LANDSCAPE AND VISUAL IMPACT ASSESSMENT REPORT

AUGUSTA ST, HUNTINGWOOD EAST 2148

Figure 18 View 7– Existing Baseline & Photomontage

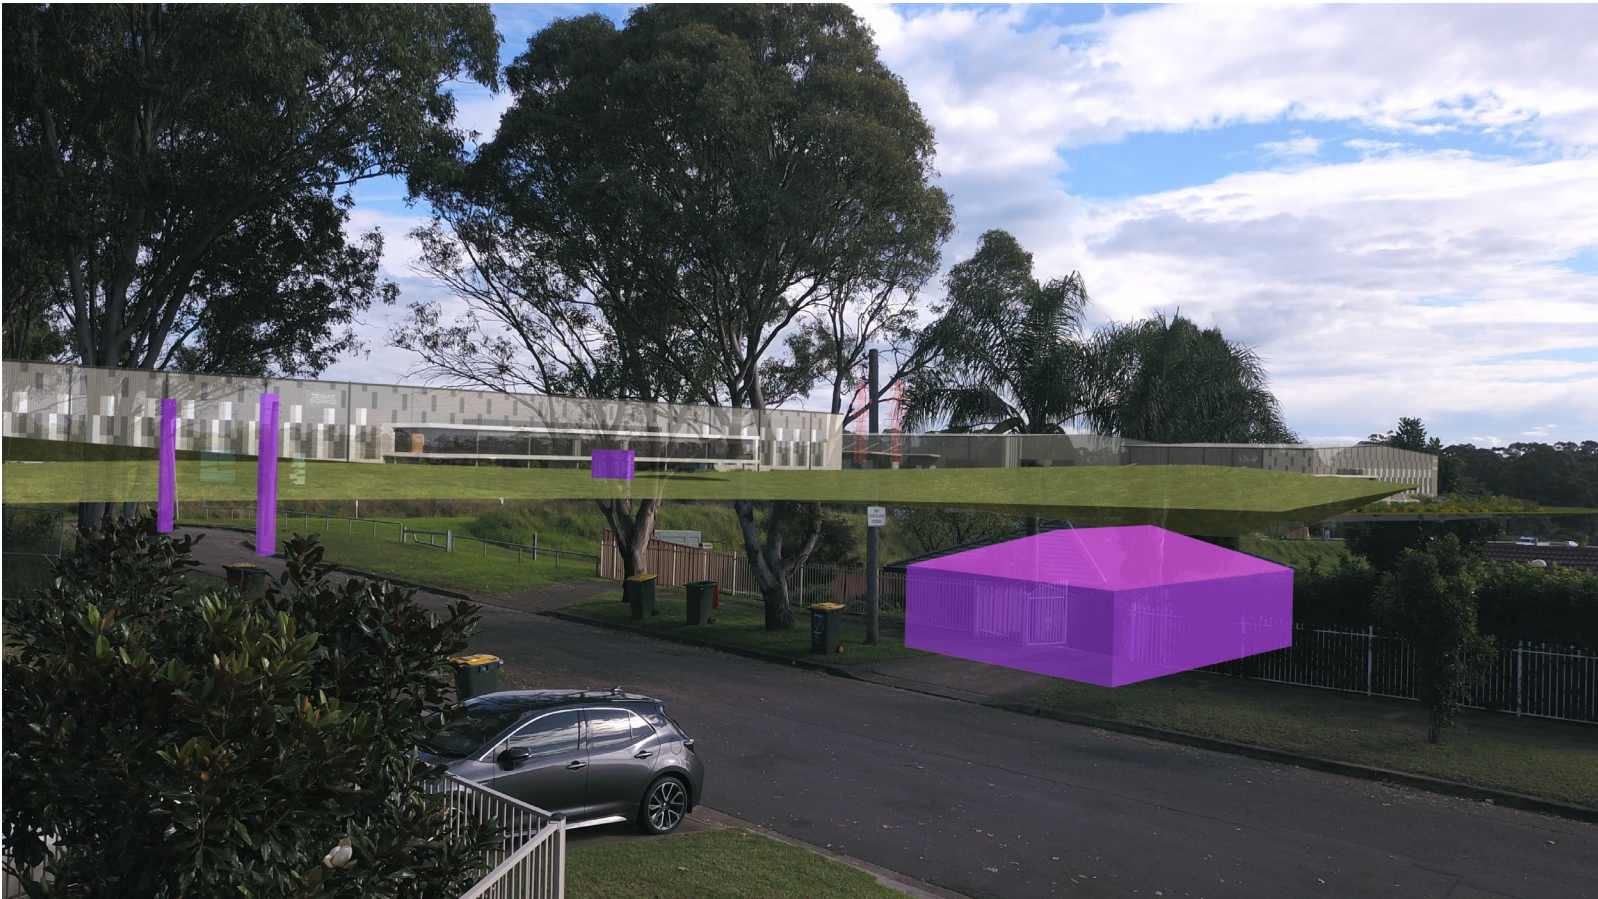
7 – Magnitude of Change	High	Very High	The existing baseline view is interrupted by a motorway , foreground “noise/detractors” including roads, cars, houses, fences and existing vegetation. Distant views are dominated by an overgrown weed infested site, some vegetation, signage and power lines . Under our proposed “high” definition the development “will be clearly noticeable, and the view would be fundamentally altered by its presence.” Under the “very high” definition the development is “creating a new focus and having a defining influence on the view.” We would describe a proposed building screened by trees adjoining a motorway cannot be considered a “defining influence” to what is a view that is of medium sensitivity.
7 – Significance of Impact	Moderate	Major/Moderate	As per Government guideline for LVIA's, the Significance of impact is determined by the Magnitude of Change description. If the magnitude of Change is higher then the impact will increase with it.

Figure 22 View 8– Existing Baseline & Photomontage

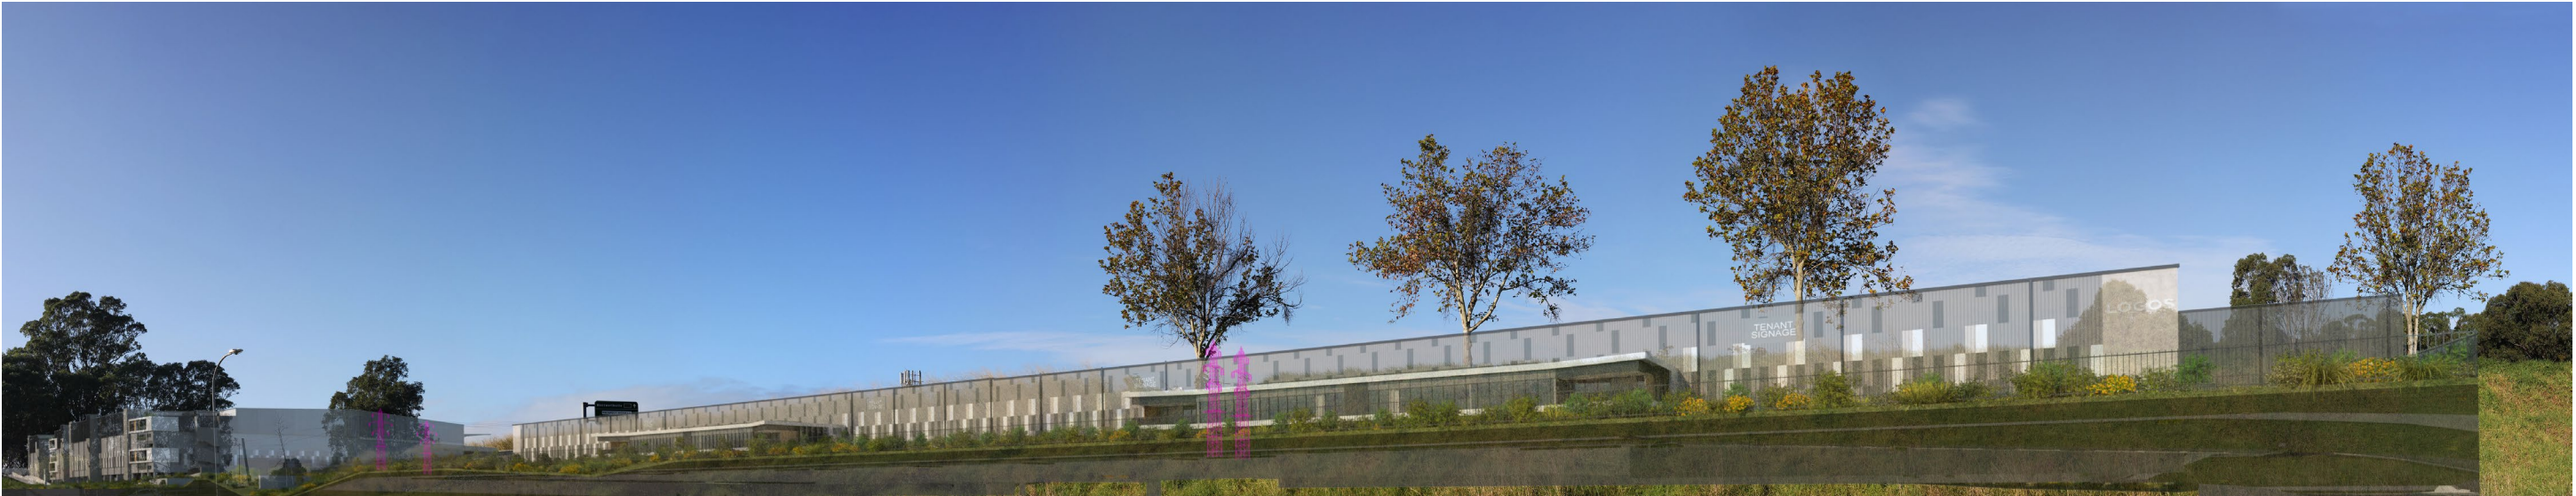
8 – Magnitude of Change 8 – Significance of Impact	Medium Minor	High Moderate	The view point is from the road reserve between the highway and the existing residential housing subdivision. An existing grassed berm and the sunken topography limit the built form impact on the residential properties. The proposed built form is slightly visible from these properties as it appears to “pop out” over the mound. As there are no distant views or horizon lines affected, it is not unreasonable to see parts of an industrial warehouse where land is zoned industrial. The dominant view is the foreground which consists of the vegetated berm that screens off the road corridor therefore there are no interruption to any horizon line or district views. The Magnitude of Change on this view is medium which describes the change as “the proposed development will form a new and recognizable element within the view which is likely to be recognized by the receptor. Direct or oblique views at medium range with a moderate horizontal and/or vertical extent of the view affected.” This is also reflected in the additional viewpoints 8A, 8B, and 8C, which demonstrate the minor/moderate impact to the visual receptor's along Tyne Place.
